Administrative Approval Action

Case File / Name: ASR-0065-2019
3601 MARCOM ST.

REQUEST: Development of a .925 acre site zoned R-10 into a total of nine apartment units (in 2 buildings) with associated parking and infrastructure.

FINDINGS: City Administration finds that this request, with the below conditions of approval being met, conforms to the Unified Development Ordinance. This approval is based on a preliminary plan dated October 28, 2020 by Thompson and Associates.

ASR-0065-2019
 PRELIMINARY SITE PLAN
 MARCOM STREET APARTMENTS
 3601 MARCOM STREET

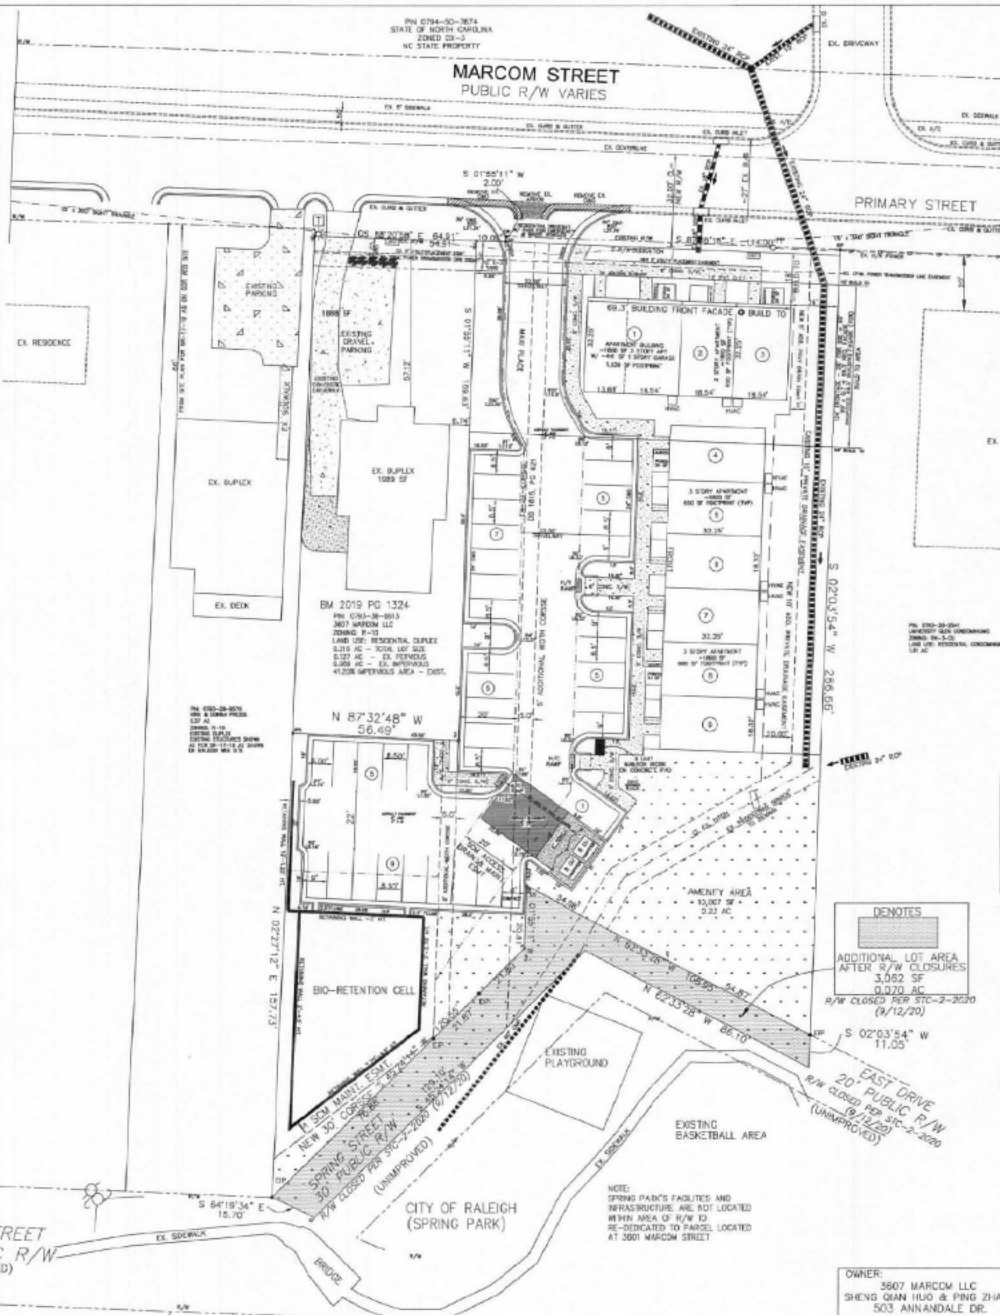
1. Demonstrate compliance with Raleigh Street Design Manual B-20.01. by providing Bike Rack Placement detail in an inset. Please review the following link for standard detail dimensions: <https://cityofraleigh0drupal.blob.core.usgovcloudapi.net/drupal-prod/COR16/B-20.01.pdf> (7.1.2.C and UDO Section 7.1.8.) and
2. Add "SRPOD" to the application on the cover sheet under "Overlay District" and
3. Documentation from utility company (letter and/or email) that they approve crossing of the utility easement adjacent to the right of way

2. A fee-in-lieu for 2.5 feet of pavement and 6 ft sidewalk along the frontage of the development is paid to the City of Raleigh (UDO 8.1.10).

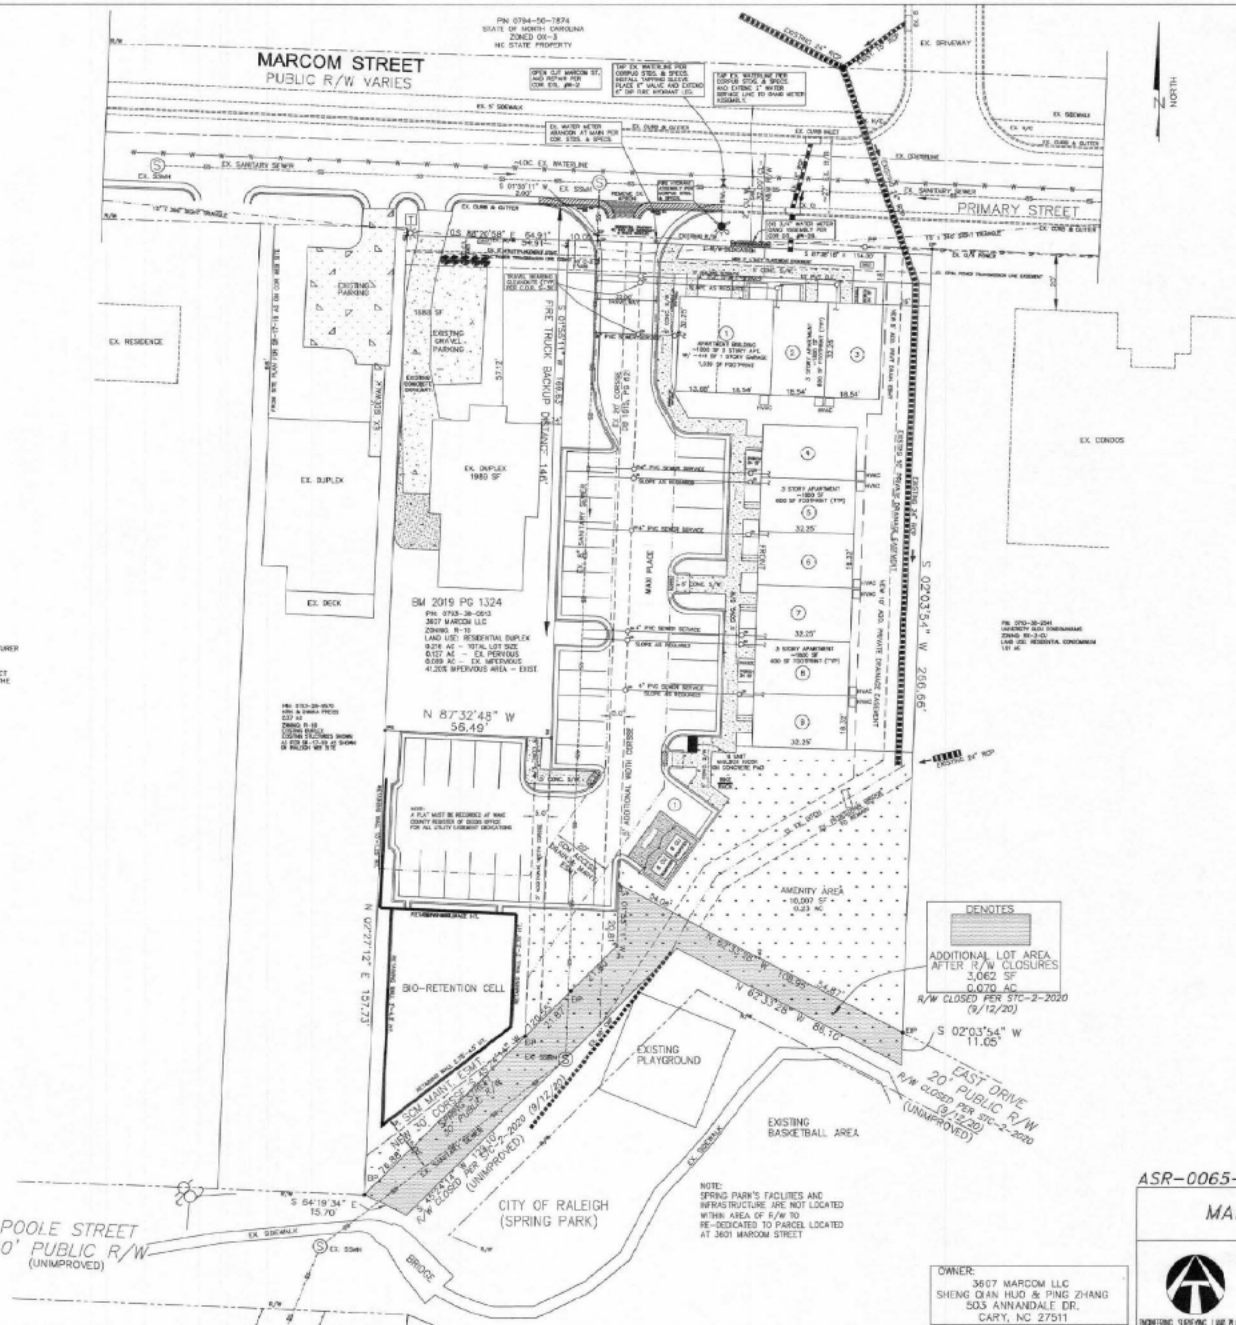
1. A 5' utility placement easement and associated deed of easement shall be approved by the City and the location of the easement shall be shown on the map approved for recordation. The deed of easement shall be recorded at Wake County Register of Deeds within one day of recordation of the recorded plat. A recorded copy of these documents must be provided to the Development Services Department within one day from authorization of lot recordation. If recorded copies of the documents are not provided, further recordings and building permit issuance will be withheld.
2. The required right of way for proposed and/or existing streets shall be dedicated to the City of Raleigh and shown on the map approved for recordation.
3. That the existing right-of-way for Spring Street is abandoned and recombined into the subject lot as proposed and a resolution number be shown on all plats.

3. A plat must be recorded at the Wake County Register of Deeds office for all utility easement dedications.
